Public Facilities Committee Agenda

Wednesday, November 3, 2021

#400-21 Petition for Grant of Location in Wells Ave
ROSCITI CONSTRUCTION COMPANY/CROWN CASTLE petitioning for a grant of location to install 188'± of 4" conduit from MH # 47/327 on Wells Ave to the proposed handhole in front of #145 Wells Ave then installing 68'± in a northeasterly direction from the proposed handhole to the building at #145 Wells Ave. (Ward 8)

To: Councilor Alison Leary, Facilities Committee Chair.
From: John Daghlian, Associate City Engineer
Re: 145 Wells Avenue Proposed Conduit Installation
Date: October 19, 2021
CC: Jim Mcgonagle, Commissioner
Shawna Sullivan, Chief of Staff
Lou Taverna, PE City Engineer
Cassidy Flynn, Committee Clerk

PROPOSED CONDUIT INSTALLATION
AT
145 WELLS AVE
IN
NEWTON, MA

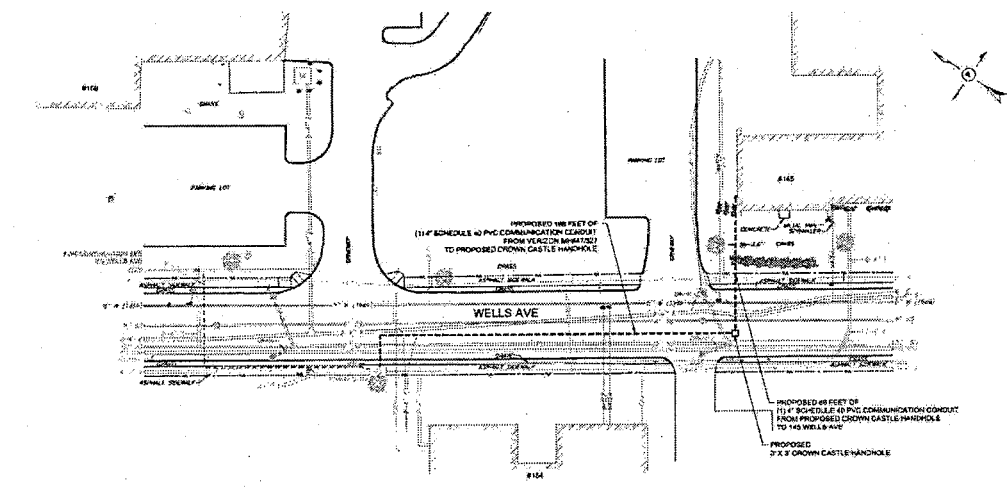
The plans have not been stamped and signed by a Massachusetts Professional Engineer; this is required by DPW.

In 2018 Wells Avenue underwent hot in place rehabilitation, therefore restoration on the roadway will require curb to curb and 25 feet beyond each end of the construction. Restoration shall be achieved by milling and overlaying 2" depth of bituminous concrete per City Specification, all curbing, sidewalks and loam borders shall be restored in kind but to current ADA & DPW Standards. The contractor of record shall obtain Street Opening, Sidewalk Crossing and Trench Permits prior to any construction with updated stamped & signed construction plans. As the City's Utility Division is not a member of Dig Safe the contractor of

record shall contact the Utilities Division 72 hours prior to construction to delineate underground water, sewer, and drain mains. Safe pedestrian access shall be accommodated by the contractor within the construction zone with approved barriers, channelization and temporary ramps approved by the DPW Inspector.

1. Finalized construction plans reflecting the above changes that meets the minimal design standards of the City of Newton must be submitted for approval by the contractor of record with appropriate Bonds & Insurance. The Engineering Division makes no representations and assumes no responsibility for the design(s) in terms of suitability for the particular site conditions or of the functionality or performance of any items constructed in accordance with the design(s). The City of Newton assumes no liabilities for design assumption, errors or omissions by the Engineer of Record.

2. The trench shall be backfilled with Controlled Density Fill CDF Type I-E Excavatable in lieu of compacted material.
3. Catch basins within the construction zone shall have siltation control measures in place and maintained for the duration without causing street or property flooding, the road shall be swept clean at the end of each construction day

4. Upon completion an as built plan shall be submitted to DPW.
5. No excavation is allowed within any City right-of-way between November 15th and April 15th. If an emergency exists or there are extenuating circumstances, Applicant may seek permission for such work from the City DPW Commissioner via the City Engineer. If permission is granted, special construction standards will be applied. Applicant or Applicant's representative must contact the City of Newton Engineering Department prior to start of work for clarification.
